MICHIGAN DEPARTMENT OF ENVIRONMENT, GREAT LAKES, AND ENERGY

RESPONSE ACTIVITY REVIEW PANEL PETITION

Facility: City of Cedar Springs, MI Former Wastewater Treatment Lagoons Site

Response Activity Review Panel
EGLE's Response to City of Cedar Springs Petition
April 7, 2022

PFAS Exceedances in Shallow Aquifer and Groundwater Contour Map. Fishbeck.
Remedial Investigation Report, dated September 2, 2021

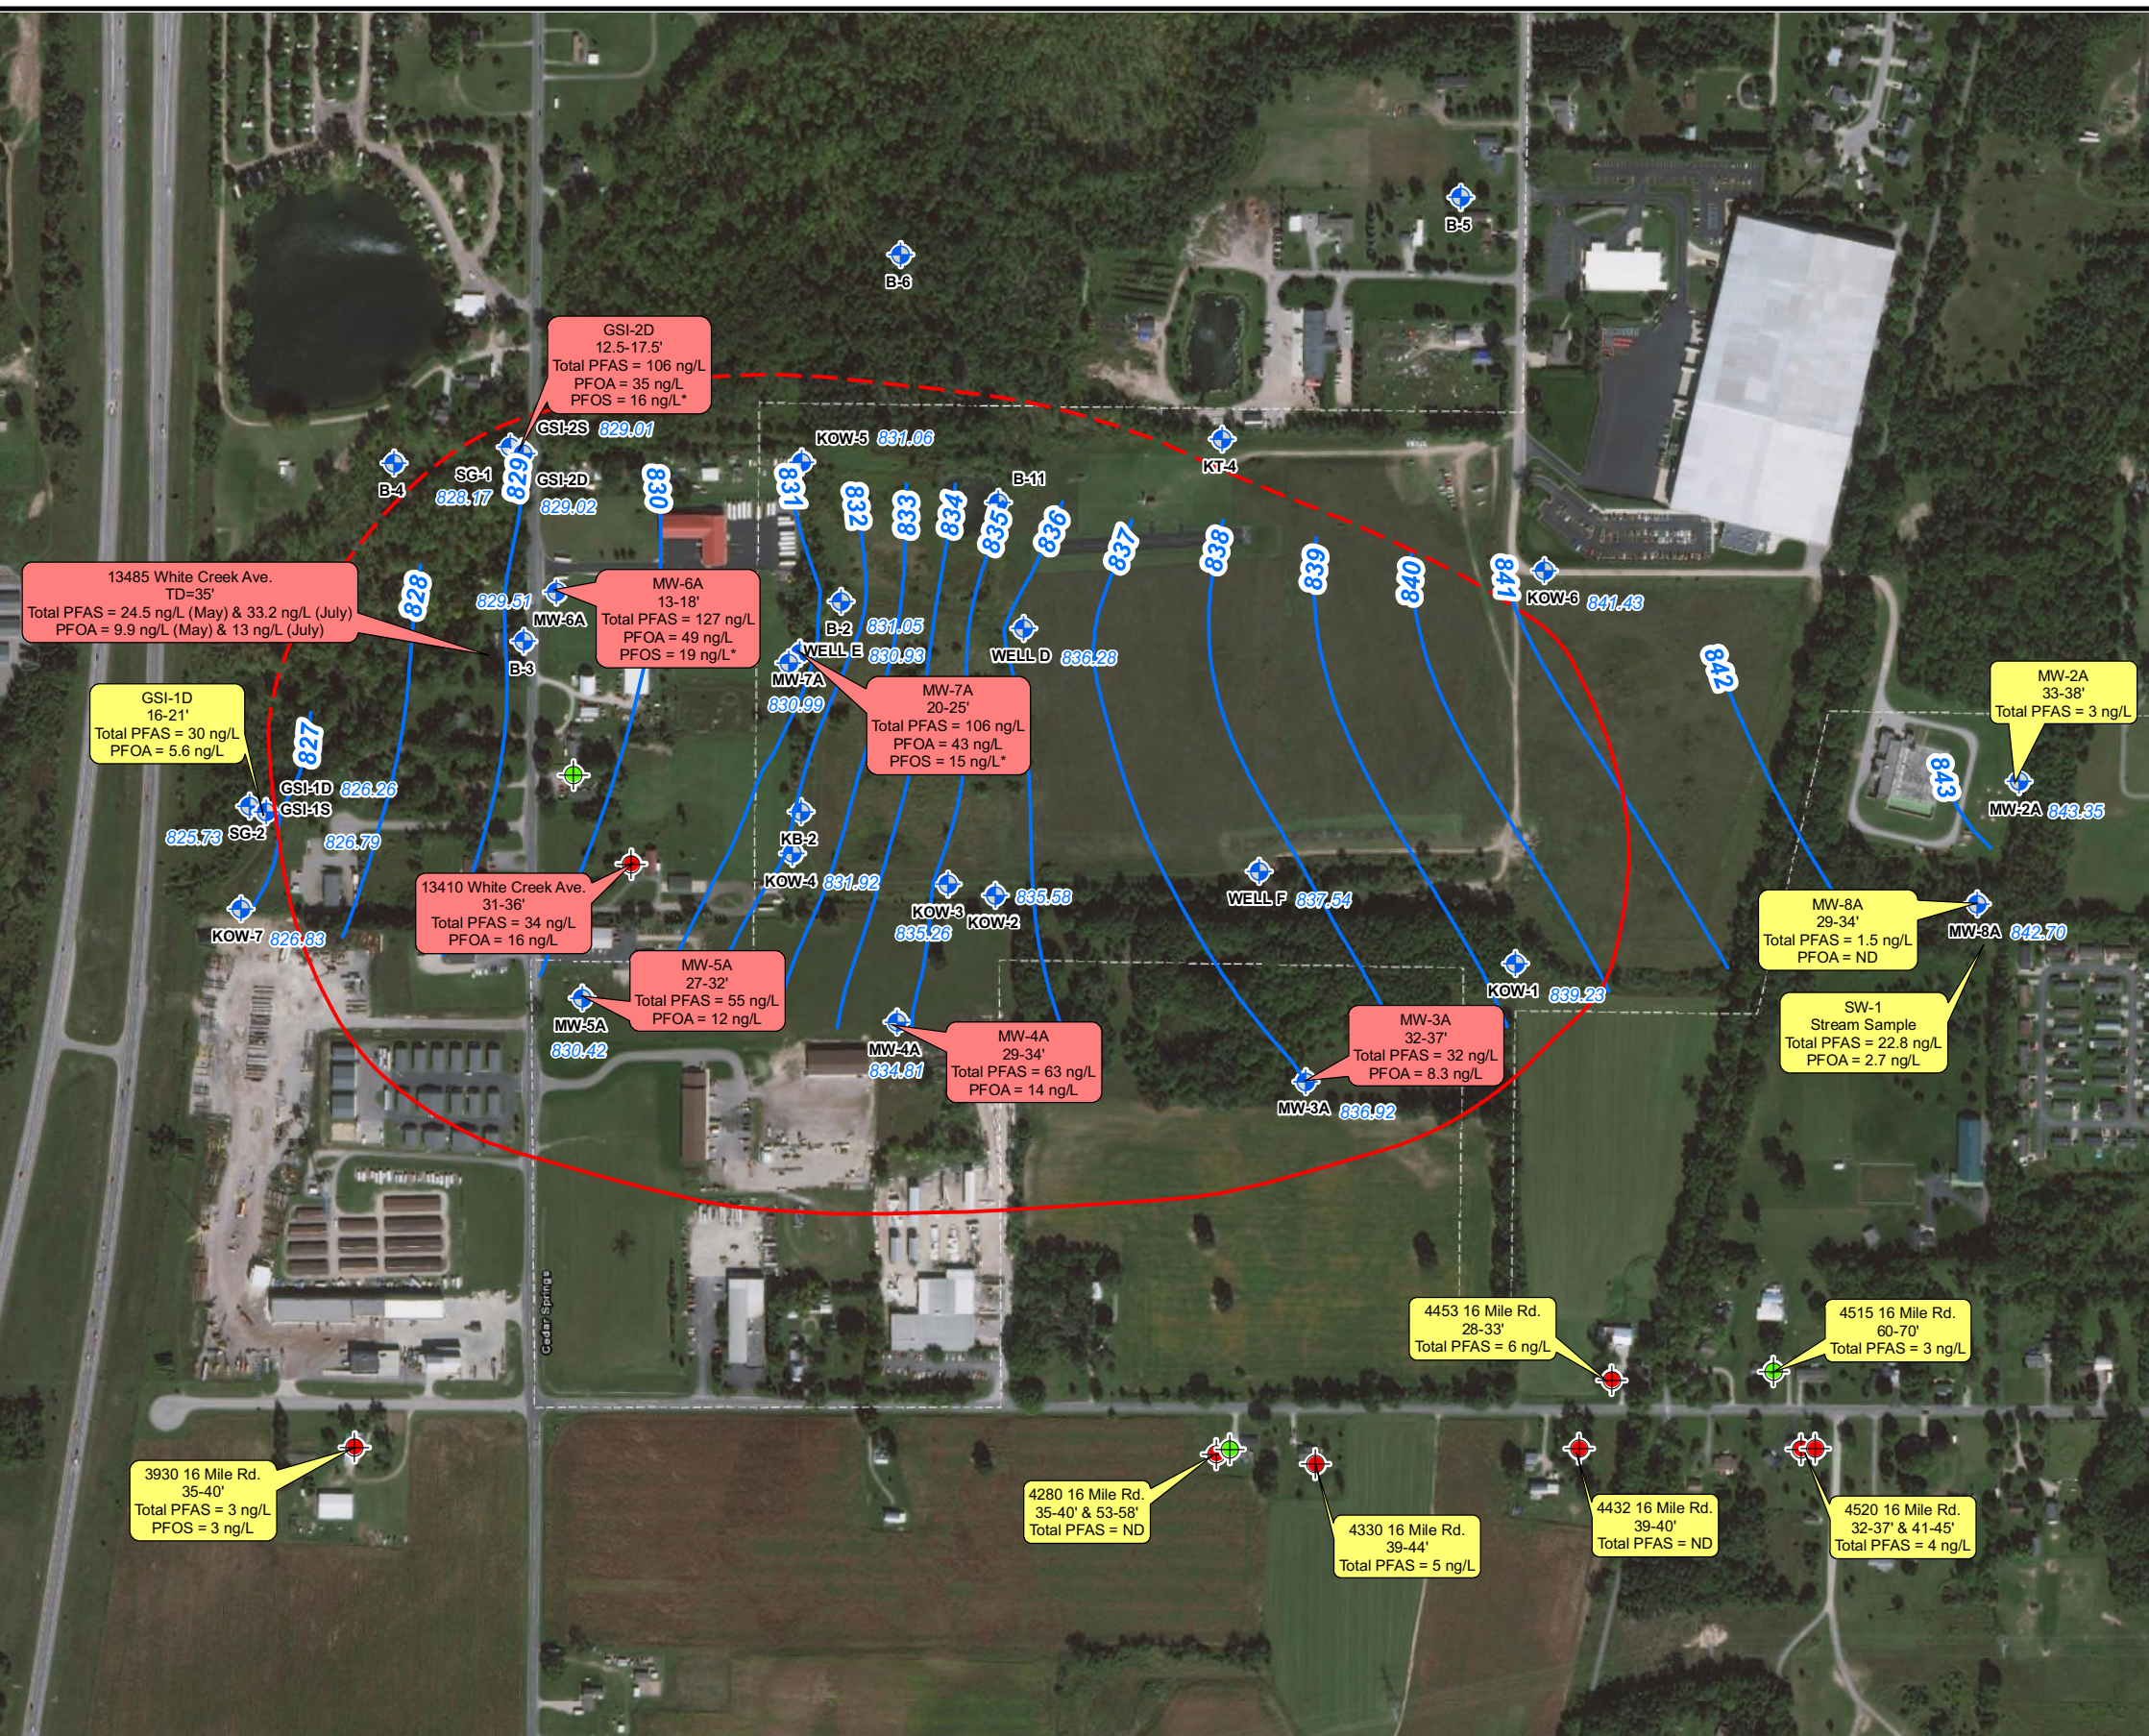
- a. **Overview:** The City used PFAS results from 11 area residential wells sampled by EGLE in combination with the results from the 8 onsite monitoring wells to propose they have delineated the horizontal and vertical PFAS groundwater contamination, shown in Figure 1 in the RI Report. It should be noted, that the City has sampled an additional 14 area residential wells near the Site for PFAS, however these residential well results are not shown on Figure 1.

“Concentrations of PFAS Compounds Compared to Part 201 Criteria”. EGLE/AECOM
Draft, dated 1/3/2022

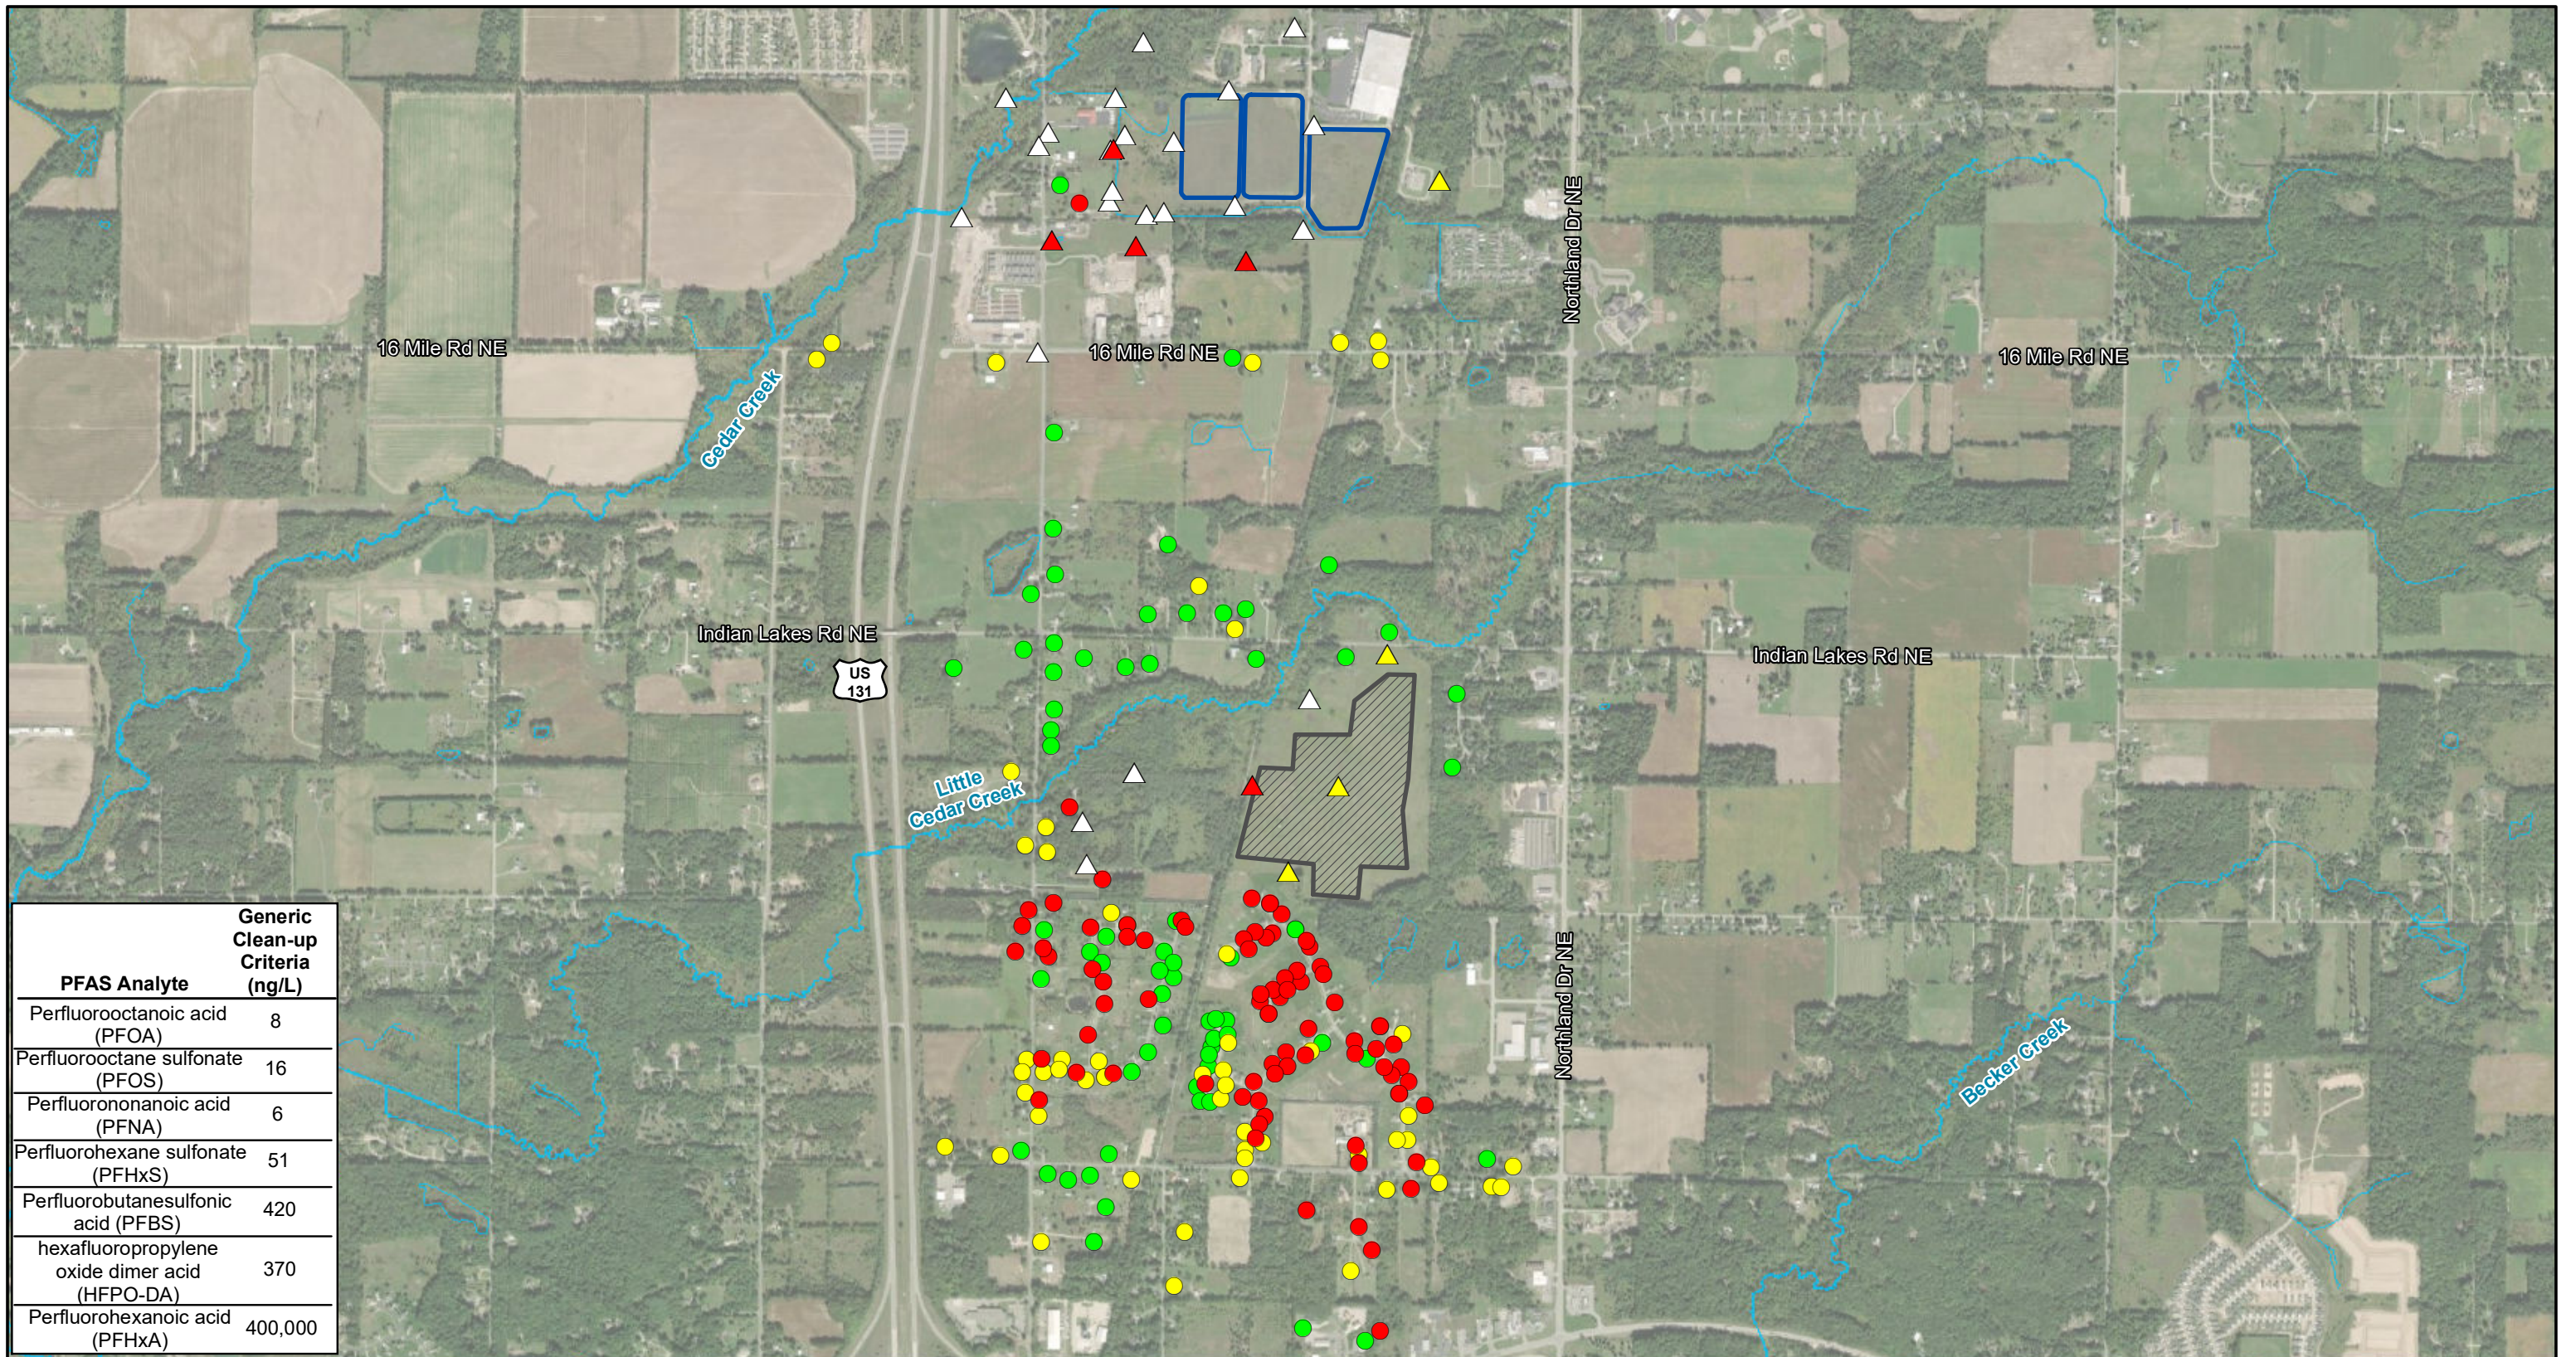
- iii. Area drinking water wells are installed in the deeper aquifer and have had detections of PFAS above Part 201 criteria, which is not mentioned in the RI Report. Refer to EGLE's Figure 2 and Figure 3 for residential well PFAS sample results and associated well screen elevations. The drinking water pathway is relevant, and the deeper aquifer needs to be investigated to verify that public health is being protected and no unacceptable exposures are occurring or have the potential to occur in the future. Residents rely on the area groundwater for private water supply wells.
